**WASCO UNION HIGH SCHOOL DISTRICT  
SHADE STRUCTURE & SITE IMPROVEMENTS  
AT WASCO HIGH SCHOOL AUDITORIUM  
WASCO, KERN COUNTY, CALIFORNIA**

Job No. 1355.1  
DSA A#03-124404

**ADDENDUM NO. #01**  
**NOTICE TO CONTRACTORS FIGURING THIS WORK**

# PARTIAL SITE PLAN \_\_\_\_\_ SCALE : 1" = 20'-0"

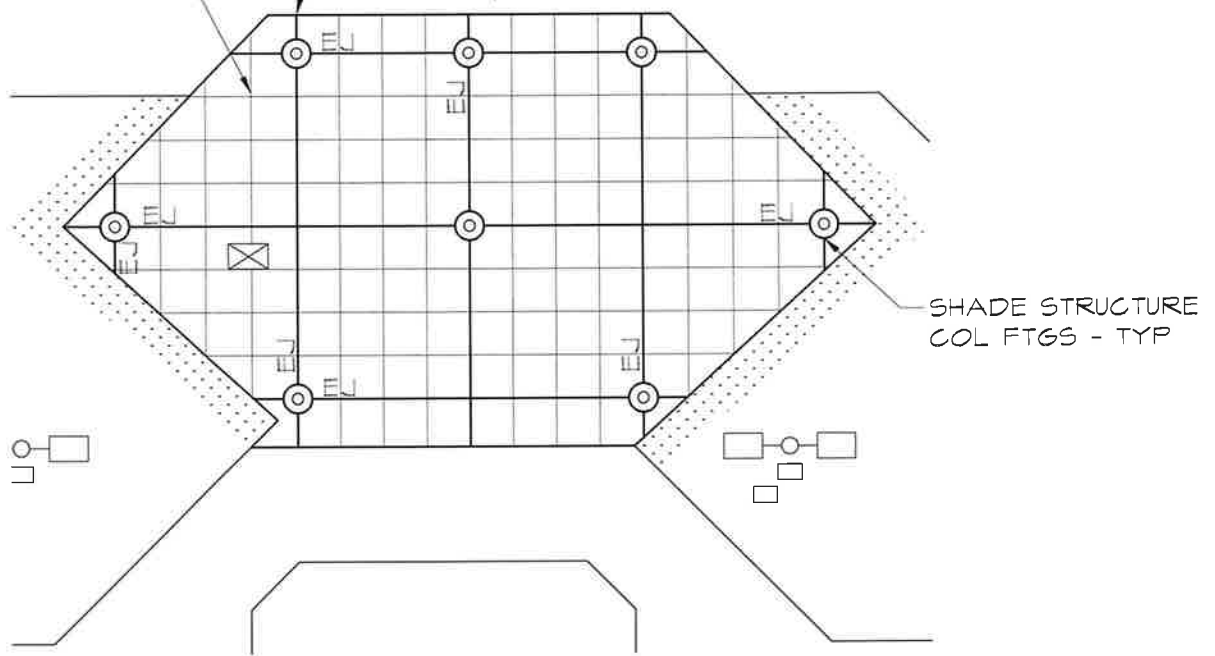
- a. DELETE: Supplemental General Condition No. 2, b. 1.05 Allowance in it's entirety.
- 1-5) Refer to DSA Approved Drawings, Sheet No. A1.1 PARTIAL SITE PLAN, PARTIAL DEMO SITE PLAN & DETAILS, A PARTIAL SITE PLAN;

- a. CLARIFY: Expansion joint and control joint layout as indicated per attached Drawing No. 01.

CJs TO BE 4 EQ  
SPACES BETWEEN  
EJs IN EA DIRECTION

EJs CENTERED ON SHADE  
STRUCTURE COLUMN FTG.  
IN EA DIRECTION

NOTE:  
CJs TYPICAL
